# AGENDA

## NORTHERN BEACHES LOCAL PLANNING PANEL

**WEDNESDAY 3 APRIL 2024**

**ITEM 4.1      DA2023/1128 - 27 REDMAN ROAD, DEE WHY - DEMOLITION WORKS AND CONSTRUCTION OF A RESIDENTIAL FLAT BUILDING.**

**Figure 1** - Extract from proposed plans, long and cross section of building height plans and height blanket on 3D Model - Source Mackenzie Architects

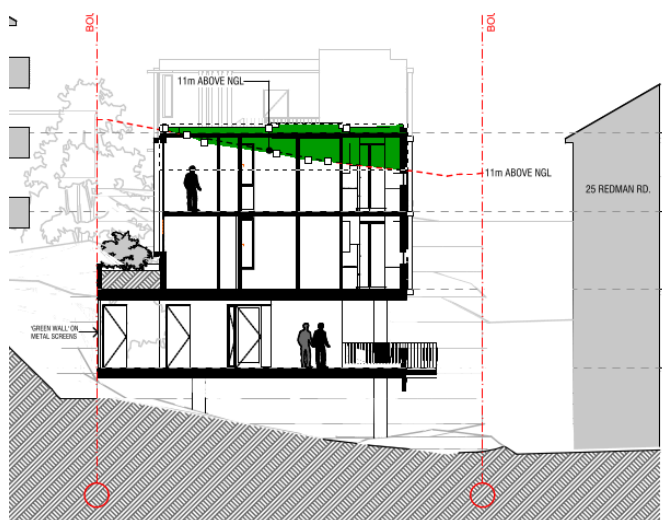
When using survey levels, the proposal exceeds the maximum permitted building height, proposing a maximum height of 13.2m above existing ground level. This equates to a maximum variation of 20%. The non-compliance is demonstrated on the figures below:

**Figure 1 - Envelope non-compliance eastern facade**

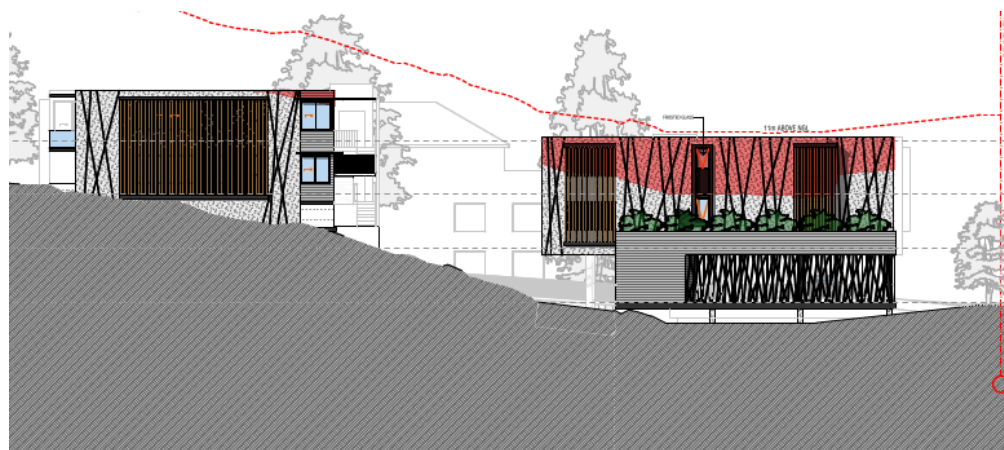
The figure below show the location and extent of the non-compliance.

**Figure 1 - site plan**

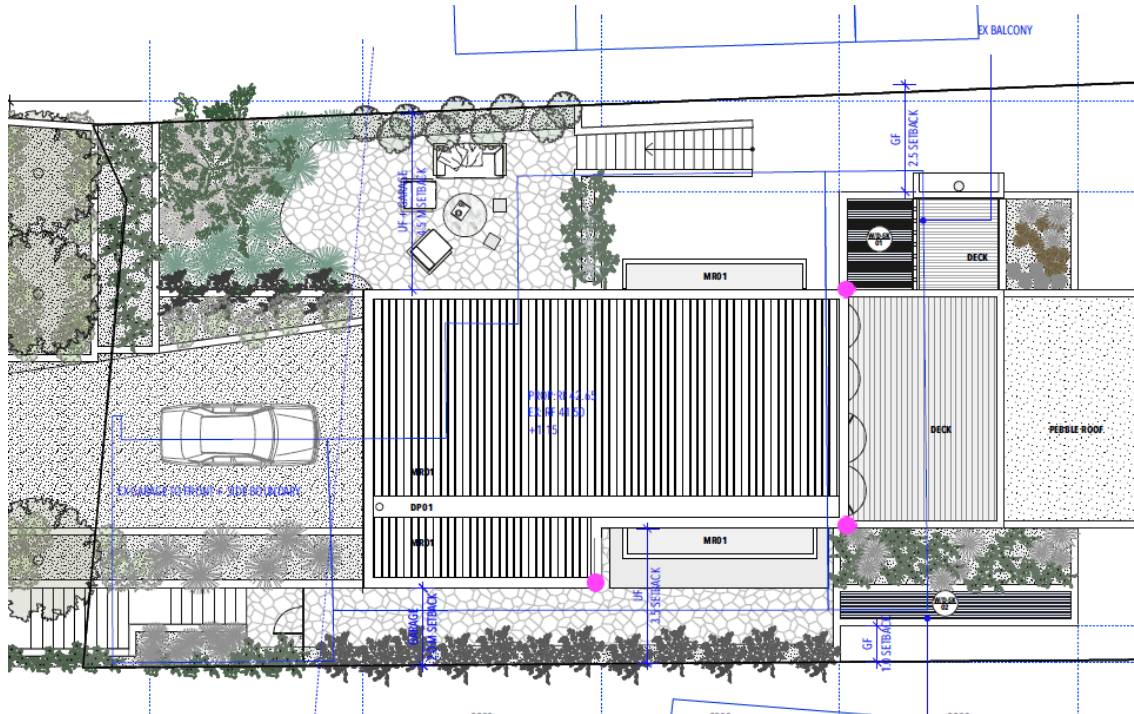
During the course of the notification, a number of submissions were received, in regard to the potential loss of views from both private properties and the public domain. The specific properties which raised concern with loss of views from their dwellings, were: Nos.119, 123, 174 and 176 Narrabeen Park Parade.

For the benefit of the assessment, the applicant assisted by erecting height poles, to illustrate the heights of Level 2 and 3, on their east elevation. The height and location of these poles were confirmed by a registered surveyor, in documentation dated 23 September 2023, in the locations shown below (in pink):

**Figure 6 - extent of building envelope breach**

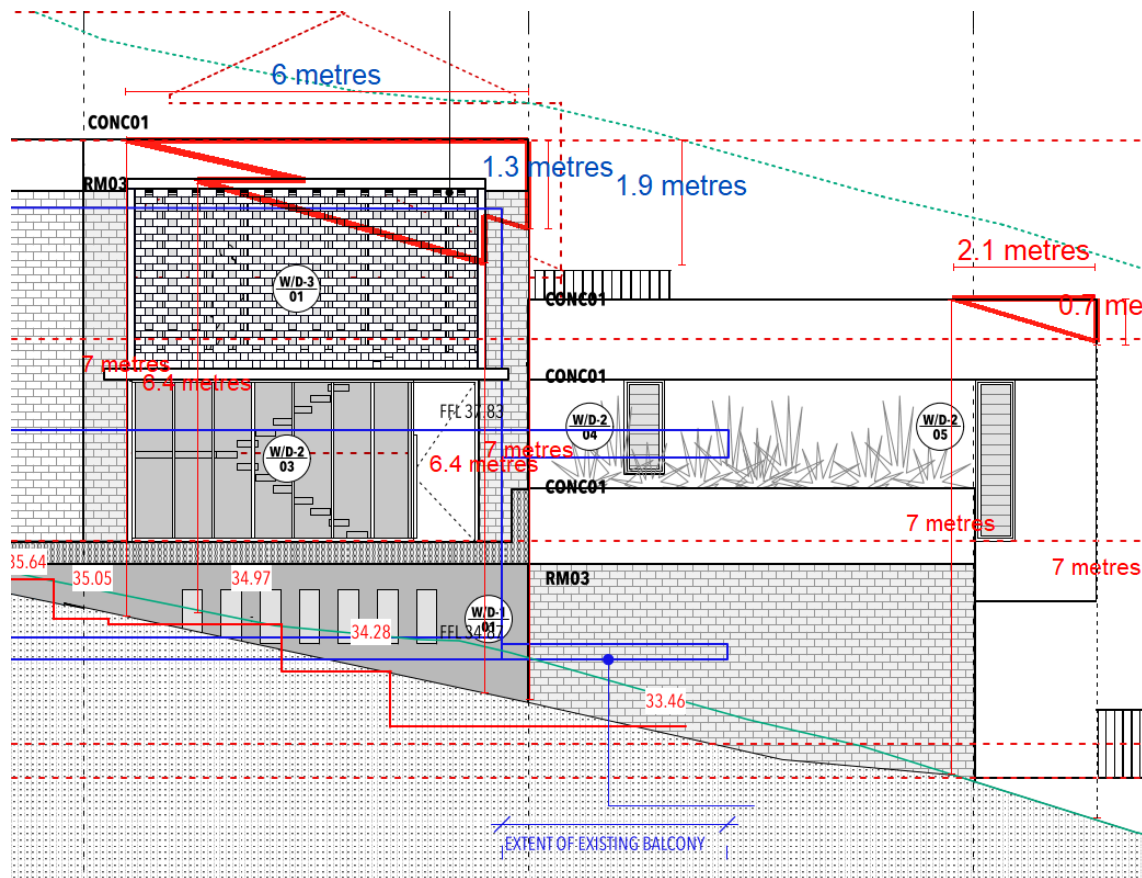
Level 3: 1.3 - 1.9 metres (height) x 6 metres (length)

An estimate of the breach is shown below (in red):

**Figure 1 – Foreshore building line breach identified in red**

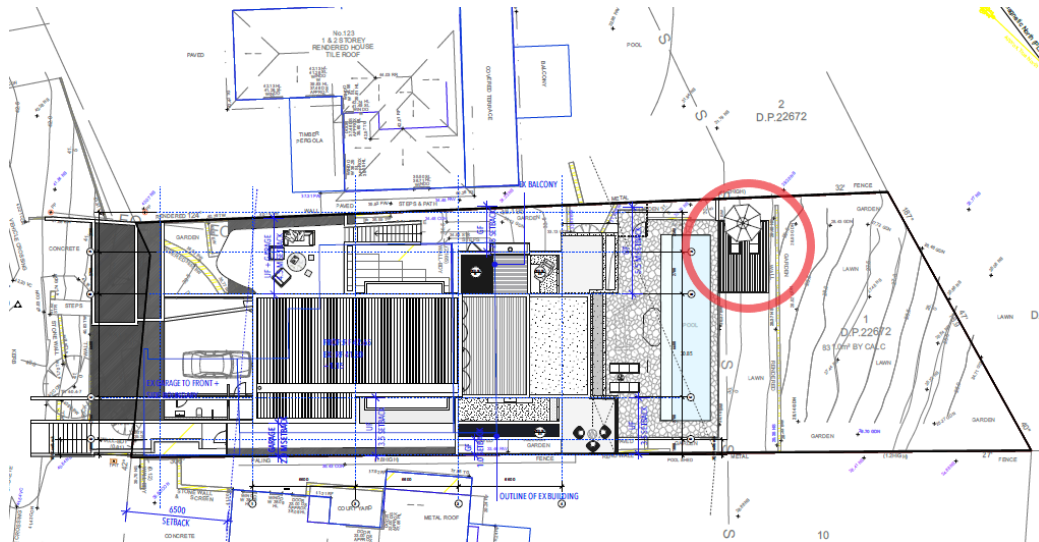
I confirm that the additional decking seaward of the swimming pool will encroach within of the foreshore building line, as highlighted below.

**Figure 1:** Excerpt from applicant's Clause 4.6 outlining the height of the new pergola

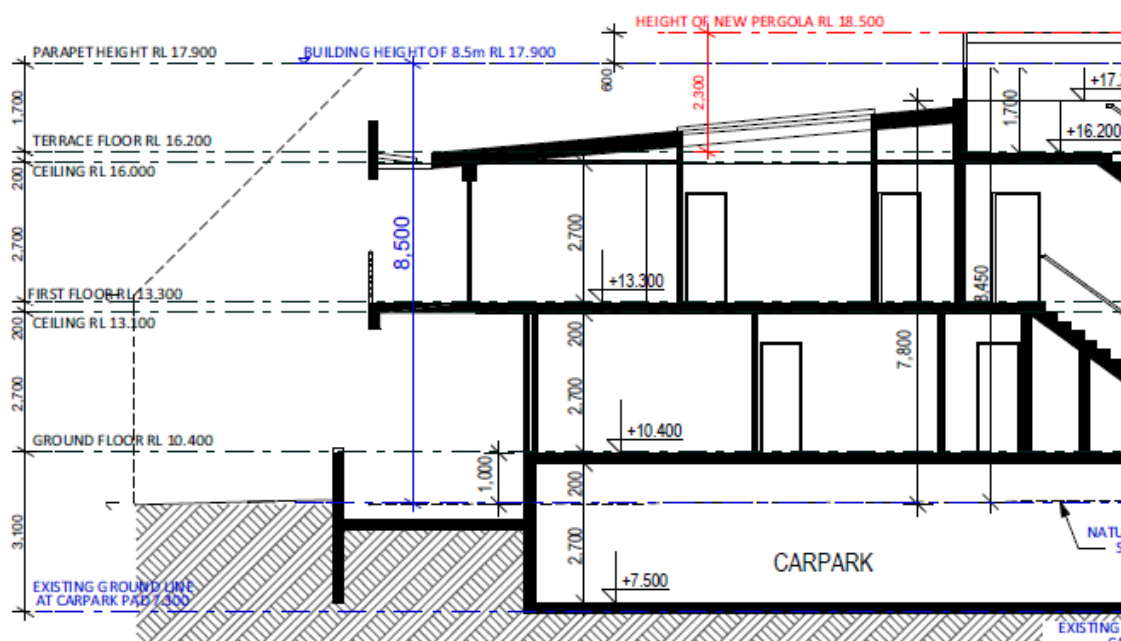
Council agrees with the applicant that the variation is as a result of historical excavation for the basement level of the existing RFB, the works are not expected to have any unreasonable amenity impacts and will not be highly visible in the streetscape given the design and location of the pergolas.

**Figure 1 - extent of height breach**

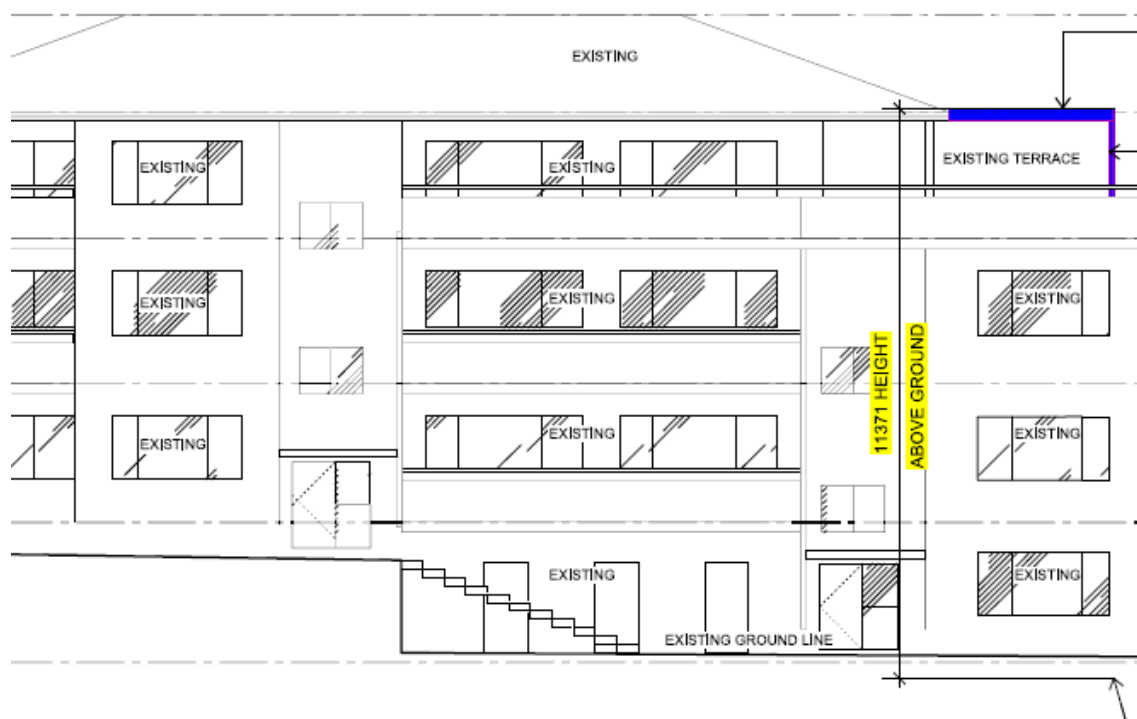
Development standard:	Height of buildings
Requirement:	8.5m
Proposed:	10.9m
Percentage variation to requirement:	28.2%
